FM Notification Report Serial Number 10-05

10CFR 21.21 (d)(3)(ii) Notification

**Facility:** PSE&G (Hope Creek)

Electronic Speed Switch (FM P/N 11916260)

Figure 1

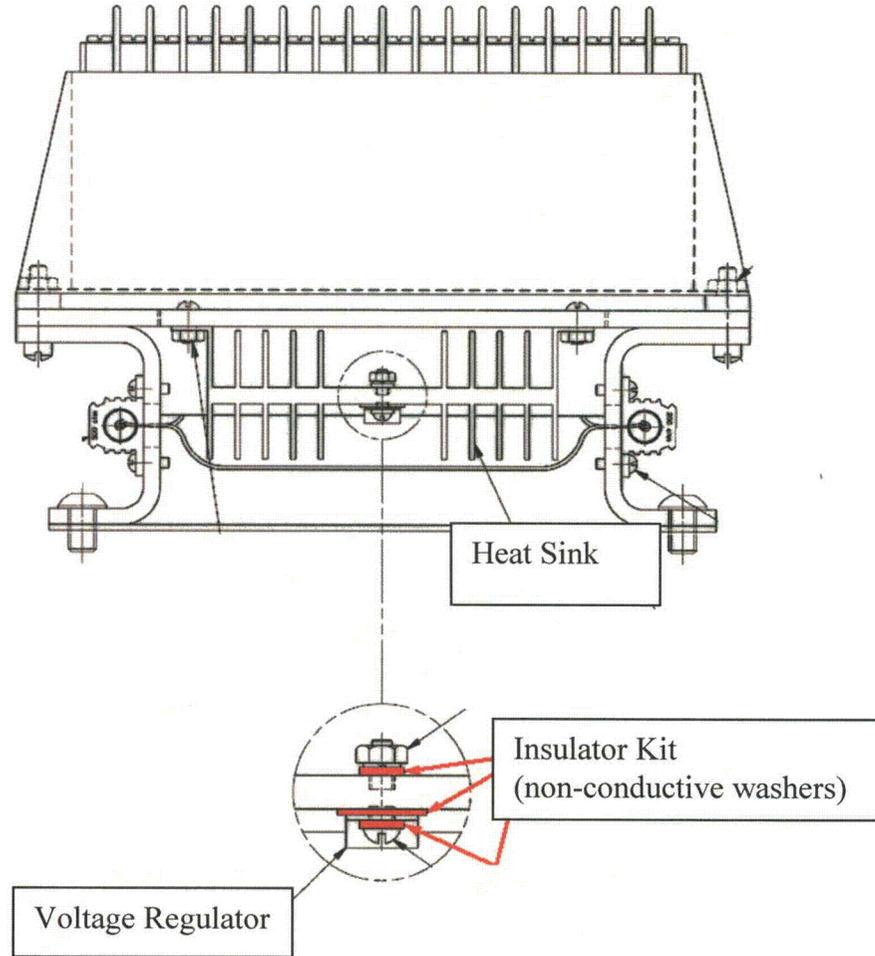
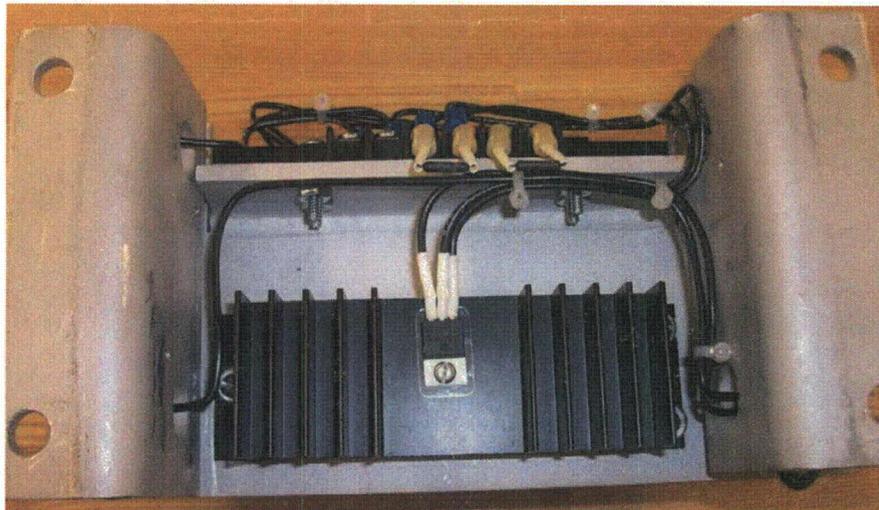
Fairbanks Morse (FM) evaluation has determined that a potential safety hazard existed for the original FM P/N 11916260 created from FM P/N P12620666 rev 0 that was delivered to Hope Creek. Subsequent to shipment to Hope Creek, additional testing found that when the speed switch assembly was mounted on a conductive surface, the voltage regulator grounded out the 24 vdc power through the heat sink preventing the speed switch from operating.

By adding an insulator kit, the speed switch circuit was isolated from ground and verified as functional. The FM initial design of the speed switch did not include the insulator kit (non-conductive washers) that would electrically isolate the voltage regulator from the heat sink and thus the metal mounting surface.

The one affected unit 11916260 created from P12620666 rev 0 was recalled and modified by adding an insulator kit (item 23) between the voltage regulator (item 8) and the heat sink (item 7) as shown in Figure 1. The design records have been updated accordingly. The assembly drawing, P12620666, and engineering bill of material have been updated. In addition the inspection plans for this part have been updated to include a circuit isolation check to confirm that the case of the voltage regulator is electrically isolated from the aluminum brackets. The inspectors have been trained in how to perform these checks.
